Gahcho Kué Panel - Information Request Responses
Gahcho Kué Project Environmental Impact Review

GAHCHO KUÉ PROJECT ENVIRONMENTAL IMPACT STATEMENT
INFORMATION REQUEST RESPONSES

Information Request Number: GKP 1

Subject: No assessment for sustainability of caribou populations.

Figure GKP_1-1 Model of the Assessment Approach Showing the Relationship Between Pathways and Measurement and Assessment Endpoints, and Mitigation and Monitoring

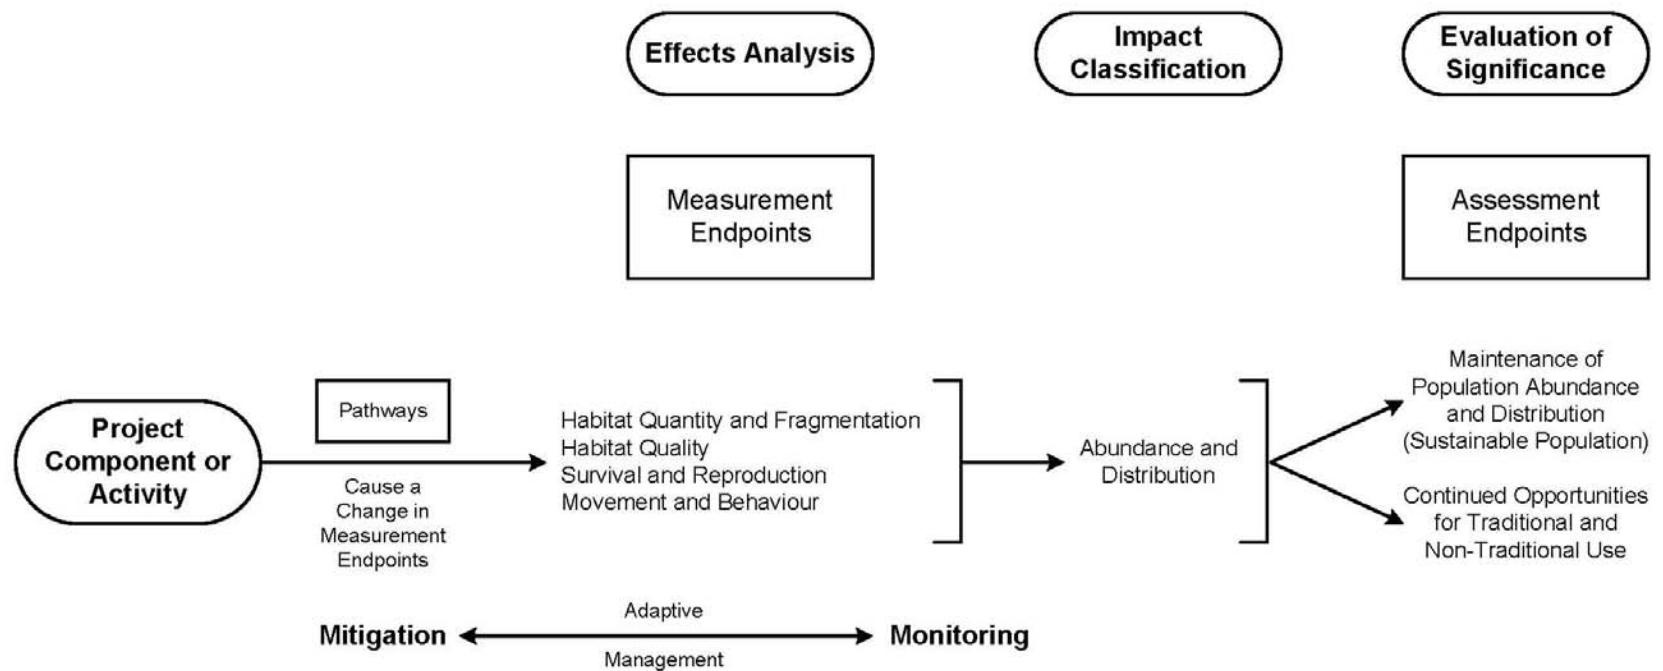
1. Please explain the relationship between persistence and sustainability.
2. Please define and explain more precisely how population persistence and continued opportunity for traditional and non-traditional uses of caribou can be measured and monitored.
3. Please provide a summary including a flowchart linking how the other measurement endpoints (such as habitat quantity and quality, survival, and reproduction) will be related to population persistence and harvest opportunities in the context of the mitigation, monitoring and adaptive management.

The EIS used several measurement endpoints to analyze changes from the Project (pathways) on the physical environment (e.g., habitat quantity and quality) and attributes of the population (e.g., survival and behaviour) (Figure GKP_1-1). Some measurement endpoints are quantitative such as habitat quantity and fragmentation, and habitat quality, and survival (e.g., direct mine-related mortality). Other measurement endpoints may be quantitative and/or qualitative depending on the type of information available. Changes in movement and behaviour are usually predicted qualitatively from the numerical analyses of habitat quantity, quality and fragmentation, and results from the available scientific literature and monitoring studies. In other words, qualitative expressions of effects are based on several lines of evidence, which included calculated changes in landscape variables and the current understanding of wildlife ecology and responses to these changes. If numerical data are available (e.g., long-term information from collared caribou, aerial and ground surveys), then changes in movement and behaviour can be more quantitative at certain spatial scales.

Changes in measurement endpoints (effects analysis) are used to predict effects on the abundance and distribution of the population, which is related to the continued opportunities for traditional and non-traditional use of caribou (Figure GKP_1-1). In other words, the assessment of availability of caribou for human use is based on the predicted effects to abundance and distribution, which is determined by examining the lines of evidence from the quantitative and qualitative analyses of measurement endpoints. Subsequently, the classification of effects (impact classification) from different pathways on population abundance and distribution (and availability of animals for human use) is used to determine environmental significance on the assessment endpoints (Figure GKP_1-1).

Figure GKP 4-1

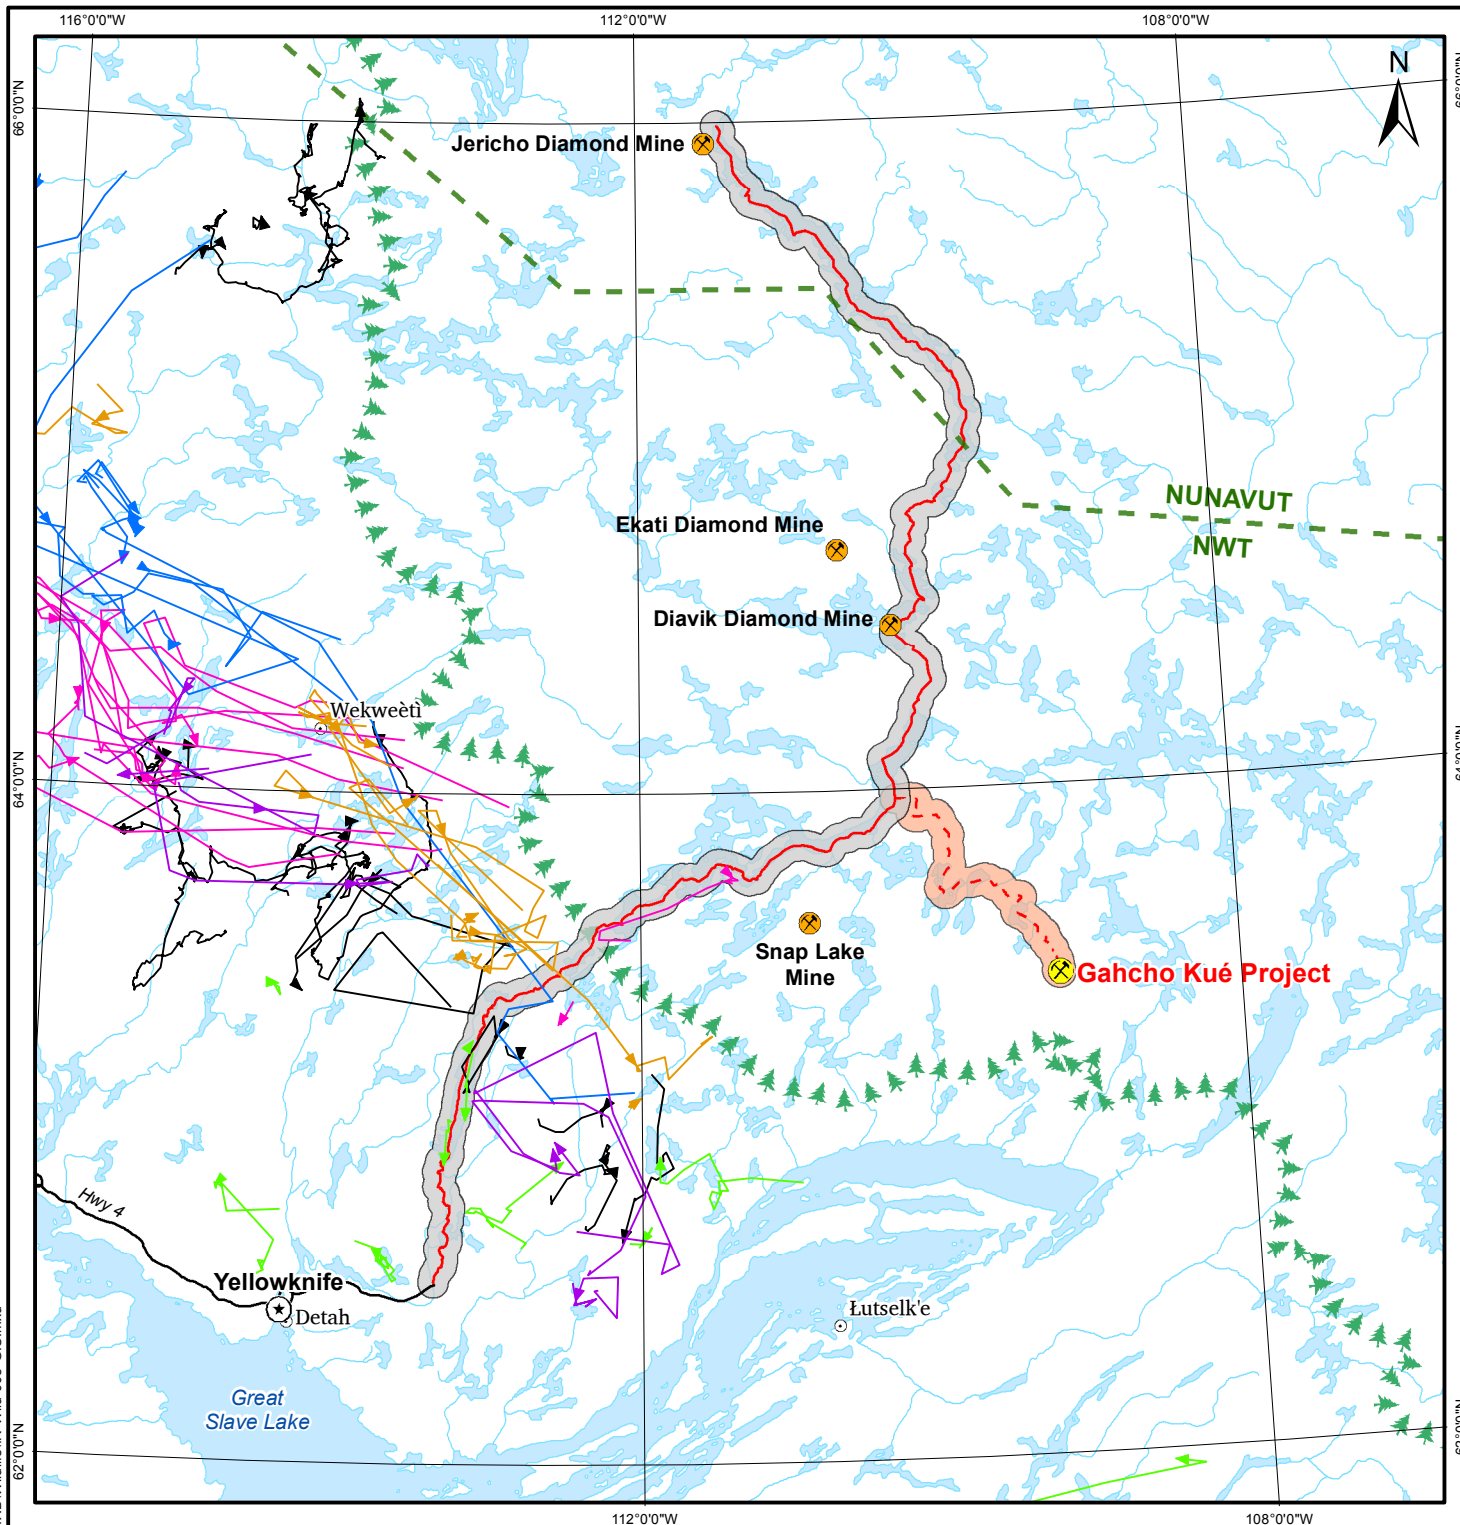
1. Provide a description and analysis of annual changes in the winter and pre-calving migration relative to the winter access road and the Tibbett-Contwoyto Lake winter road using all available information.
2. Develop encounter rates based on the satellite collared cows for the winter access road and the Tibbett-Contwoyto Lake winter road.
3. Assess the extent to which the collared cows represent the distribution of the entire herd including bulls.

The results indicated that there have been no encounters between collared caribou and the Project winter access road in any year since 1996 (Figure GKP 4-1). The Project winter access road was active in only four years, but all years were considered in the analysis. This indicates a low probability of collared caribou encounters with the Project winter access road during the active winter road season.

Figure GKP 14-1 Elevation-Volume Curves (above 402.0 m, based on the Supplemental Mitigation with Fine PKC Facility)

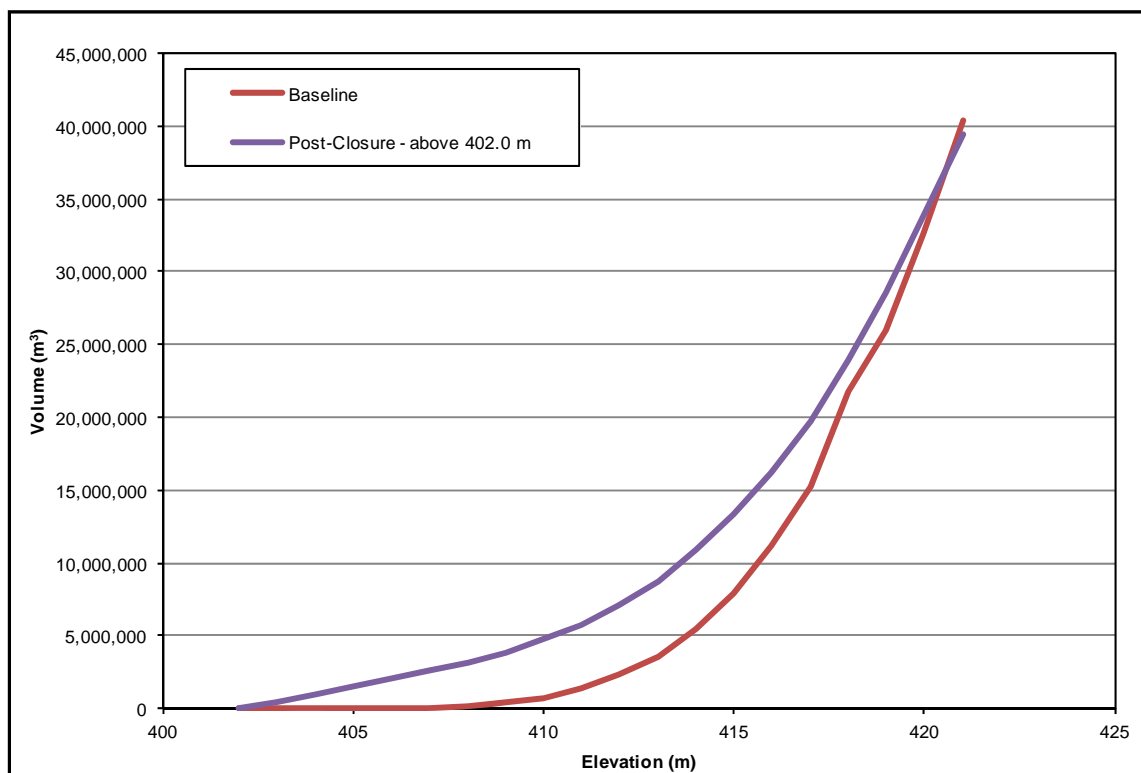
Please describe in more detail the eventual configuration of Kennady Lake and further substantiate the assertions that the lake will essentially return to normal and may for a period even experience higher fish production.

The effects of the Project on the configuration of Kennady Lake Areas 2 to 8 post closure are summarized in Table GKP 14-1 and Figure GKP 14-1, with the following key points:

Figure GKP 15-1 Caribou Pathway Analysis

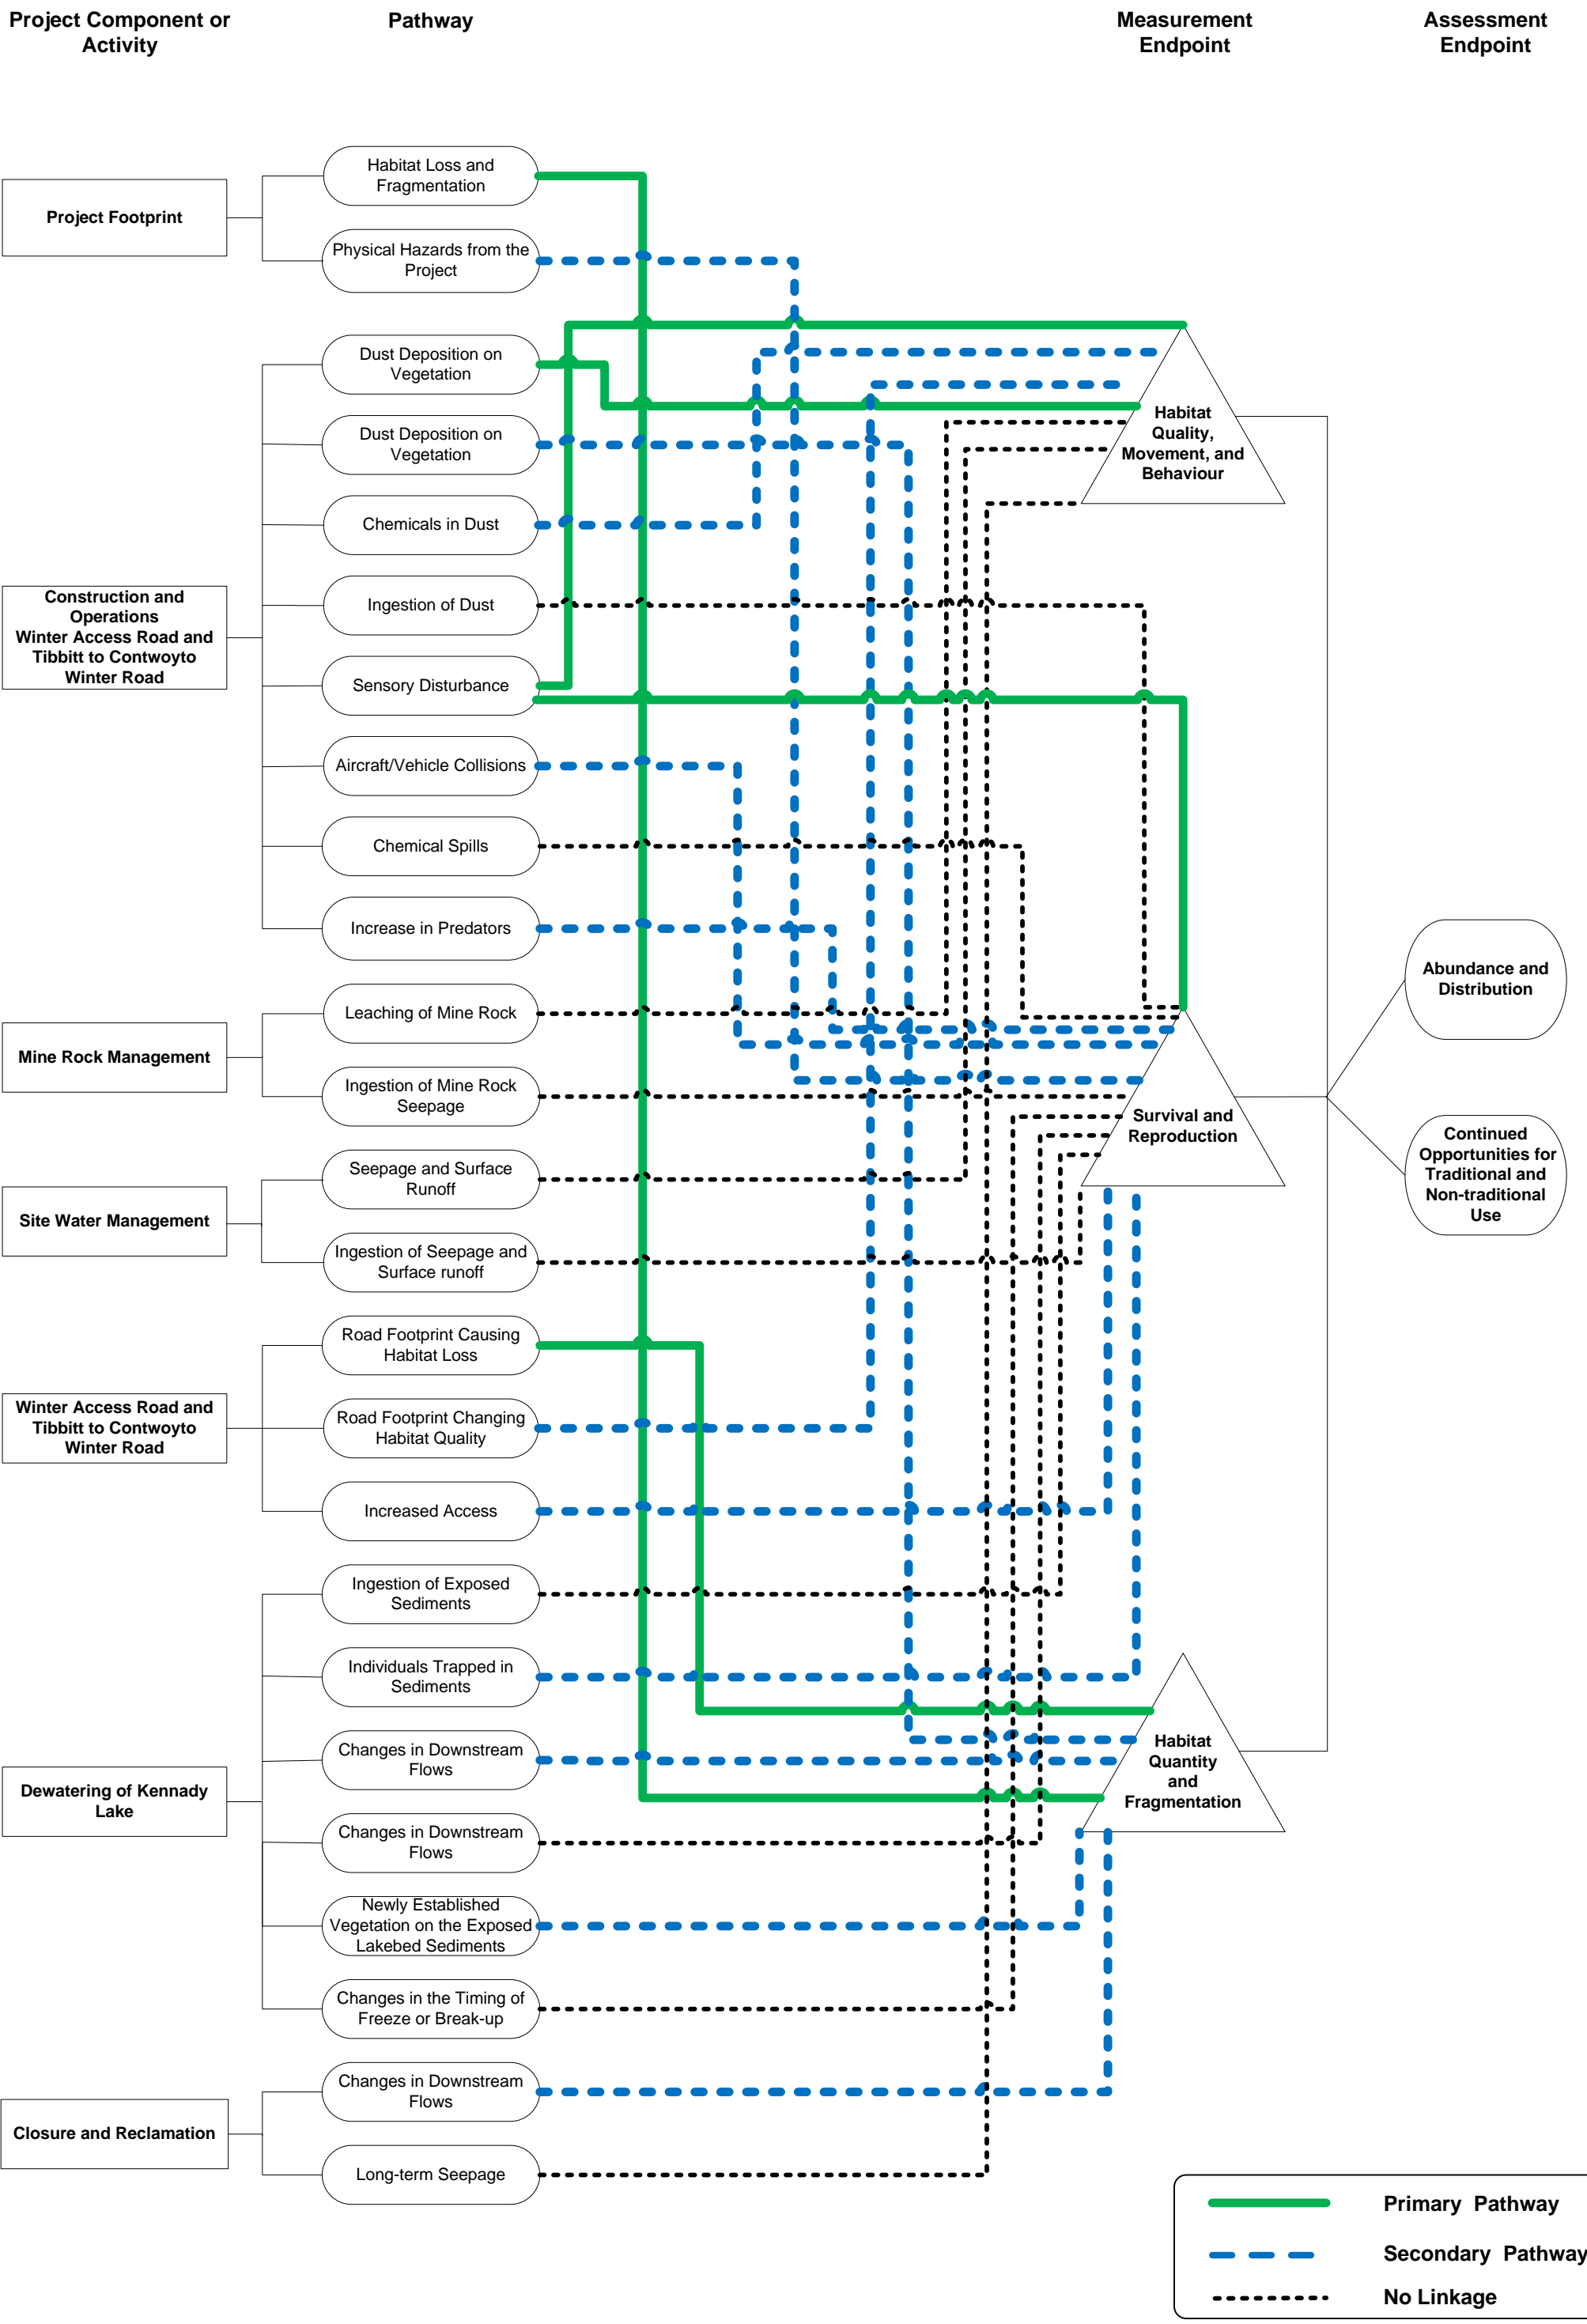
Please provide linkage diagrams [also referred to as impact hypothesis diagram] that shows all primary, secondary, and no linkage pathways that were considered in the EIS to reach the conclusions presented in Sections 13.5.1, 13.5.2, 13.5.3, 13.5.4. Ensure that if possible, the linkage diagrams show how interactions between pathways were considered (i.e., potential for additive, multiplicative, and synergistic effects), how effects on different seasonal ranges were integrated,

A linkage diagram for the assessment of impacts to caribou is provided in Figure GKP_15-1, which is a reproduction of information presented in Table 7.4-1 in the Key Line of Inquiry: Caribou of the 2010 Environmental Impact Statement (EIS). Figure GKP_15-1 also applies (with slight changes) to Table 11.10-5 (Subject of Note: Carnivore Mortality), Table 11.11-2 (Subject of Note: Other Ungulates), and Table 11.12-12 (Subject of Note: Species at Risk and Birds) (De Beers 2010). De Beers chose to present the pathway analysis for each Key Line of Inquiry and Subject of Note in table format rather than in a linkage diagram because a table provides more space for clearly describing each effects pathway, and the application of mitigation and environmental design features.

For caribou, the pathways illustrated in Figure GKP_15-1 are described and assessed in Sections 7.4.2.1 (pathways with no linkage), 7.4.2.2 (secondary pathways) and 7.5 (primary pathways) (De Beers 2010). For carnivores, no linkage and secondary pathways are assessed in Sections 11.10.3.2.1 and 11.10.3.2.2, respectively; primary pathways are assessed in Sections 11.10.4 and 11.10.5 (De Beers 2010). For other ungulates, no linkage and secondary pathways are assessed in Sections 11.11.3.2.1 and 11.11.3.2.2, respectively; primary pathways are assessed in Sections 11.11.4 and 11.11.5 (De Beers 2010). For species at risk and birds, no linkage and secondary pathways are assessed in Sections 11.12.3.2.1 and 11.12.3.2.2, respectively; primary pathways are assessed in Sections 11.12.4, 11.12.5 and 11.12.6 (De Beers 2010).
